PLAN 4

PLANNING APPLICATION PLN-20-0269

49 GEORGE STREET, PERTH

Description of proposal: Title Consolidation and Multiple Dwellings

Figure 1 – Comparison of Geoscience Australia azimuth with DA diagrams

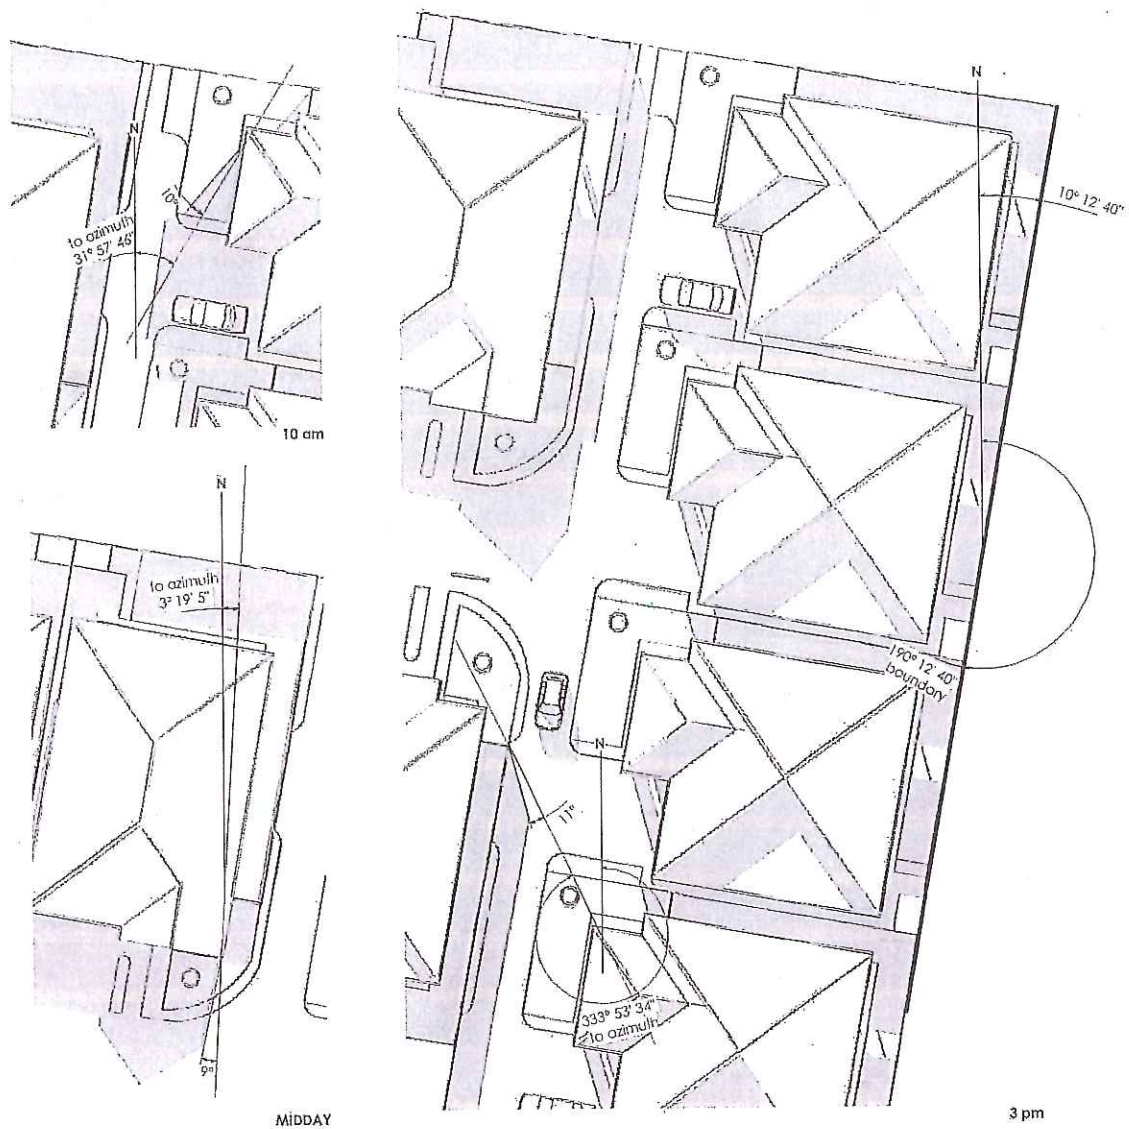
However, an error of around 10° in all shadow diagrams results, suggesting a discrepancy with the sun and/or site orientation relative to north (Figure 1).

On this basis, the private open spaces required in accordance with 10.4.3 A2 for each unit should be indicated and the accuracy of the shadow diagrams verified to ensure the robustness of any assessment against relevant clauses of the Scheme.
